**Subject: Cell 4 – Green-Croissant Pit  
Reclamation Slope Evaluation Version 2**

- Corrects typos, and mis-interpretation of the Rule to address comments by DRMS (Hays, 2022)
- Summarizes our evaluation of the existing reclamation slopes at the above referenced mine cell
- Compares our analysis to that provided by Ms. McGill (McGill, 2021)
- Evaluates the Division of Reclamation, Mining and Safety's (DRMS's) correspondence intimating a regrade requirement of Zones 9, 20, 25, 26 and part of 27 (Hays, 2021)

ZONE 26

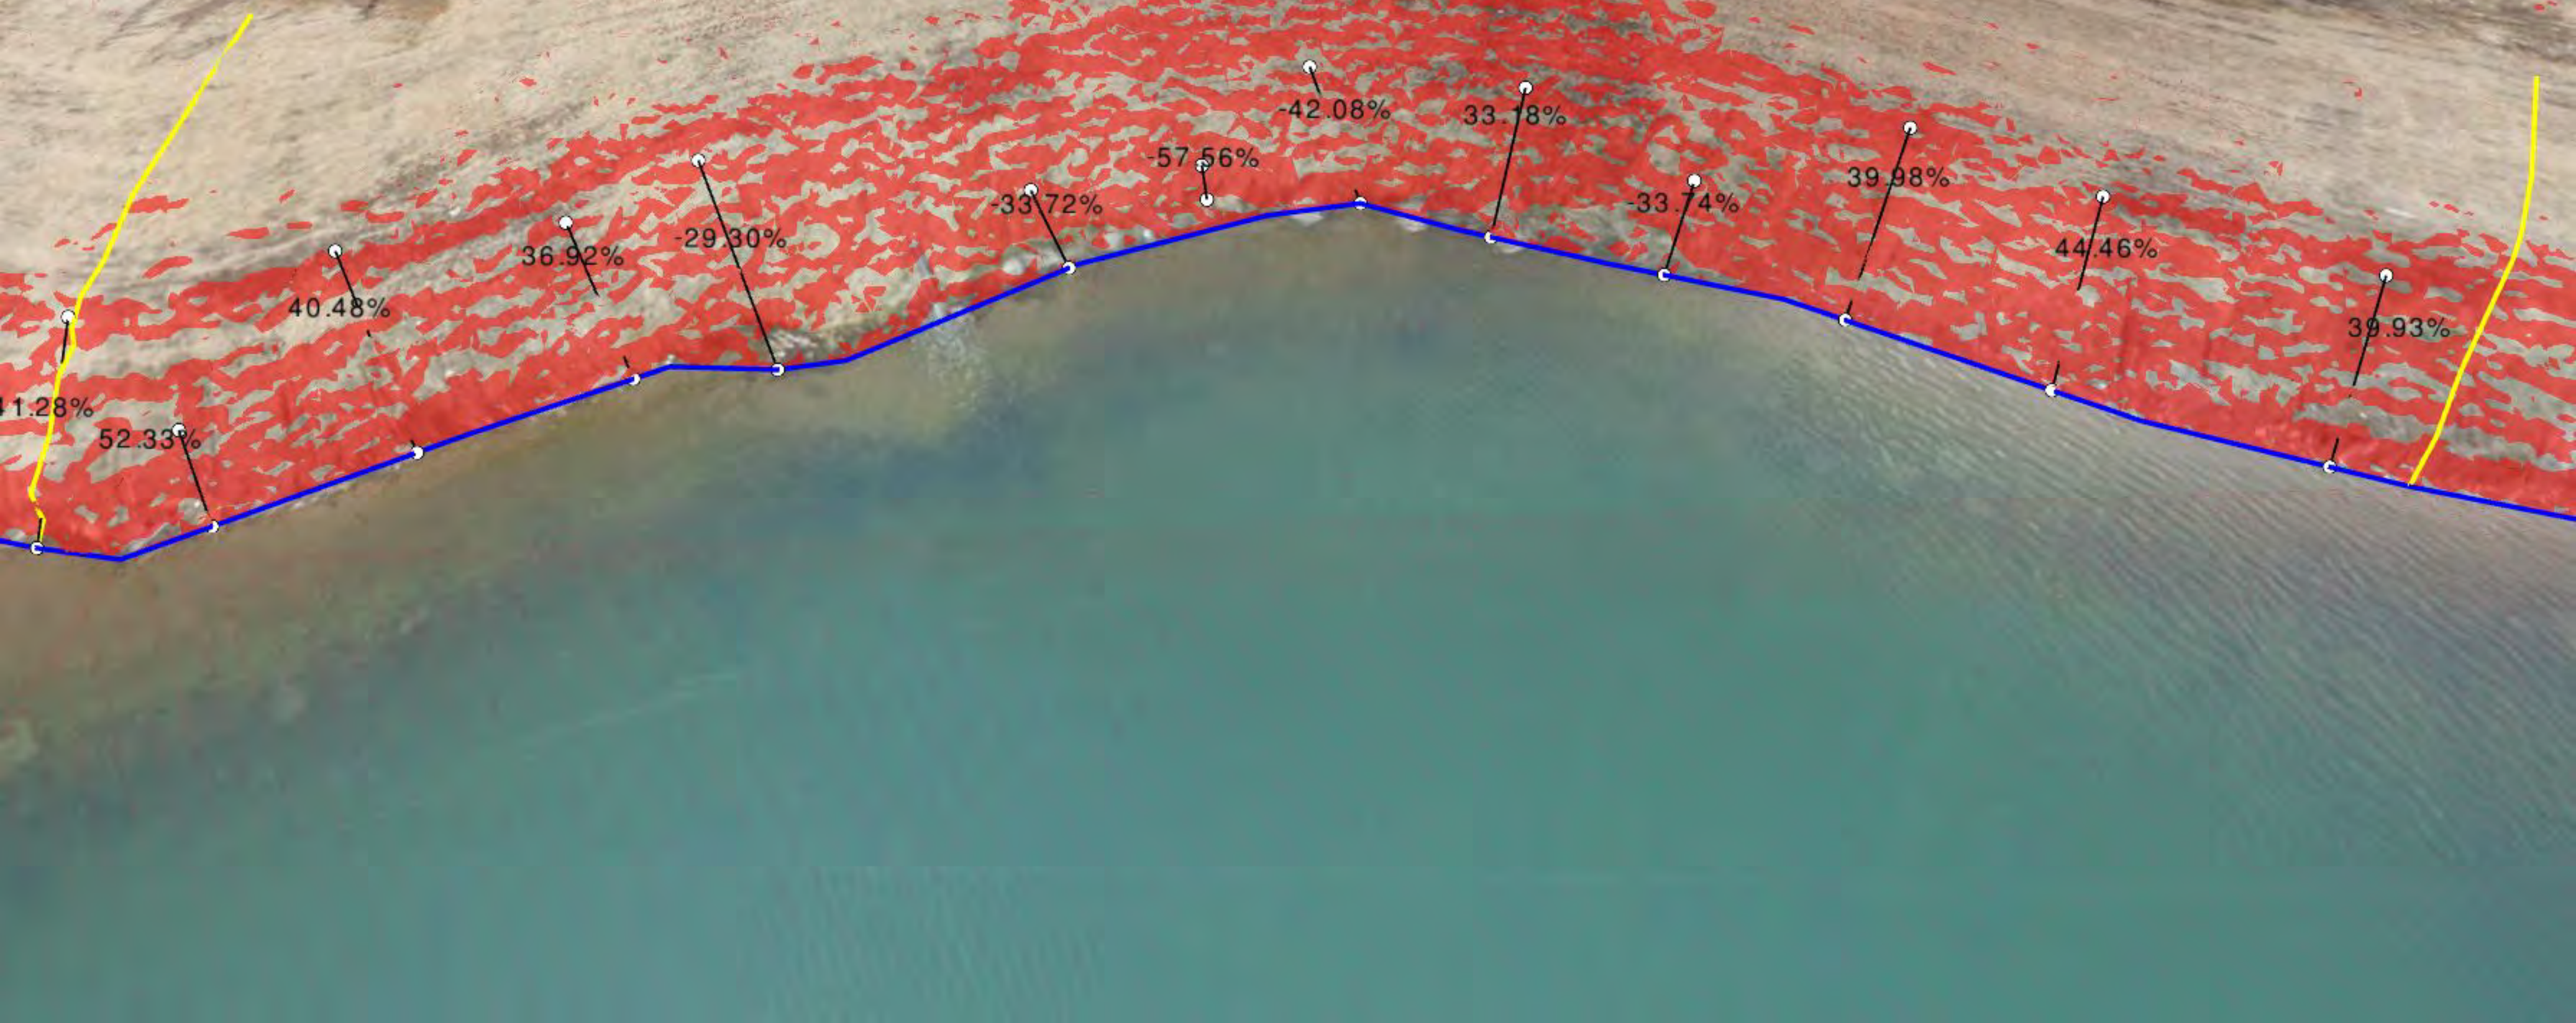
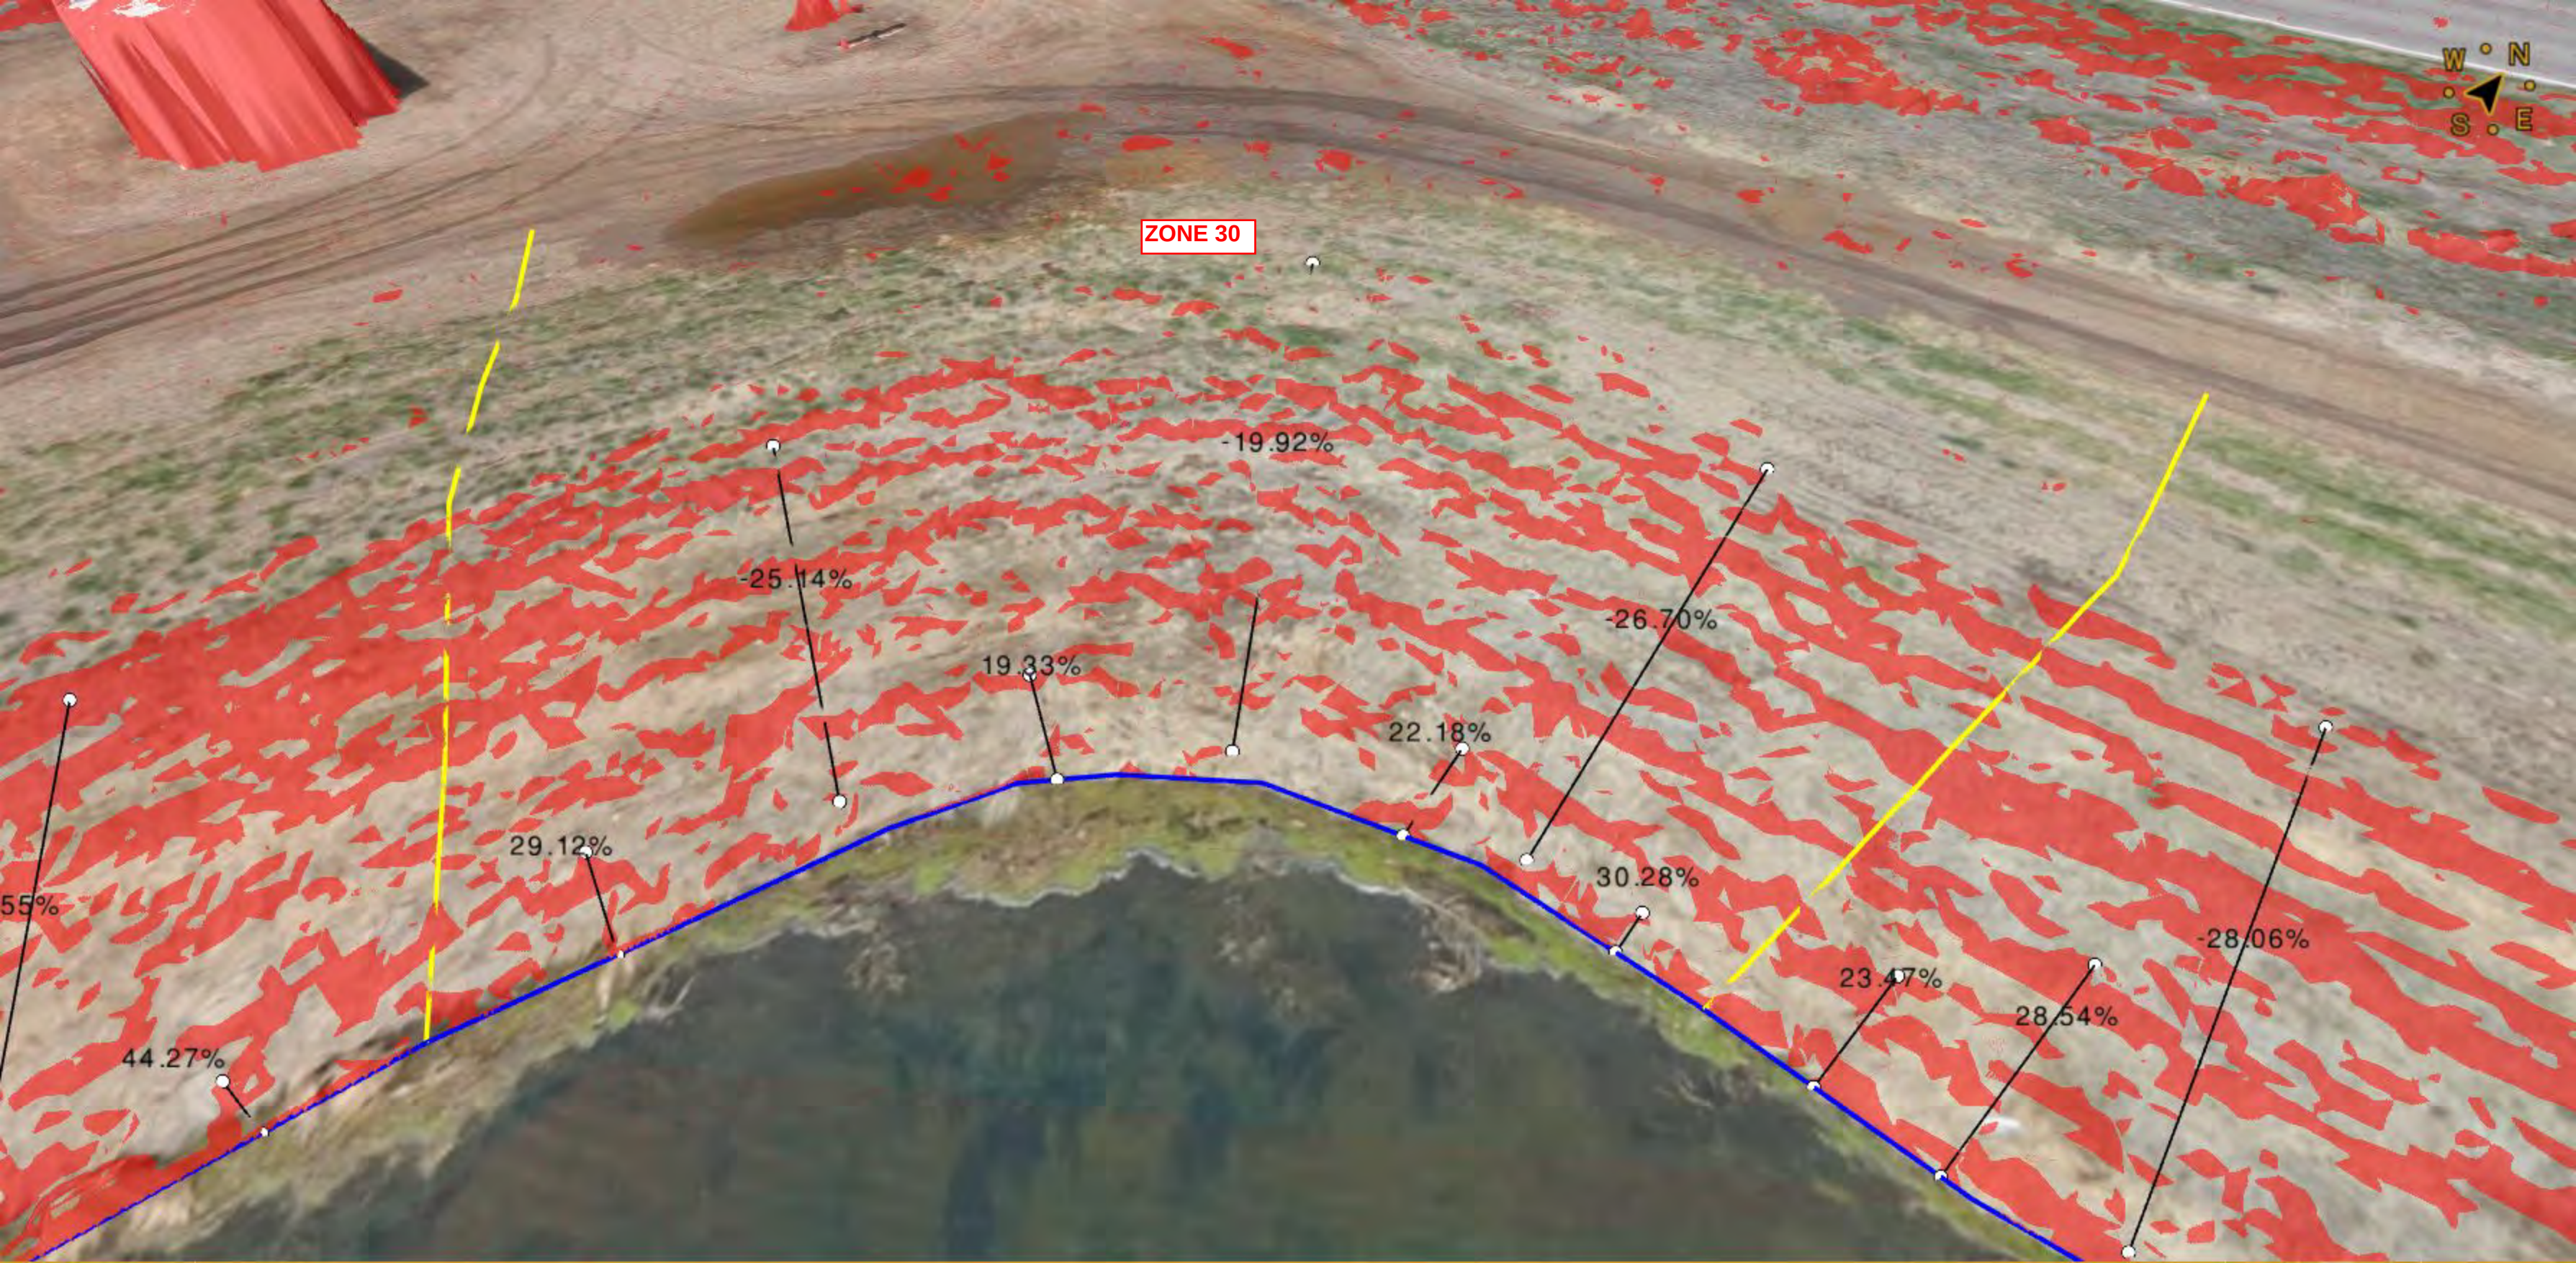
Here are the final pictures and these areas are actually dangerous. There are 3 feet of straight drop off of shoreline into the lake making impossible to reach the waters edge without falling in.

9: attached. Based on a review of the results, the Division will require Loveland Ready M  
to  
10: regrade Zones 9, 20, 25, 26, and the south end of Zone 27 to comply with Rule 3.1.5(7)  
which

Zones 25-b, 26-a, and 26-b for 10 feet below the water surface elevation are noticeably steeper than the Rule requirement, and yet shallower than 2H:1V. Given that the slopes are significantly shallower above the water surface and the overall slope is shallow, there are no stability concerns. However, you may wish to request a variance from DRMS as allowed in the Rule for these small areas.

The questionable areas of Zone 25 and 26 shown in the cross sections (Sheet 1) are stable and shallower than 2H:1V. If DRMS required LRM to regrade the upper portion of the slope, the design would be to excavate the excess at the crest and haul stockpile it nearby (you would not want to push it into the pond as it would settle at angle of repose, exacerbating the slope issue). This would result in an approximately 10-foot cut into the existing road.
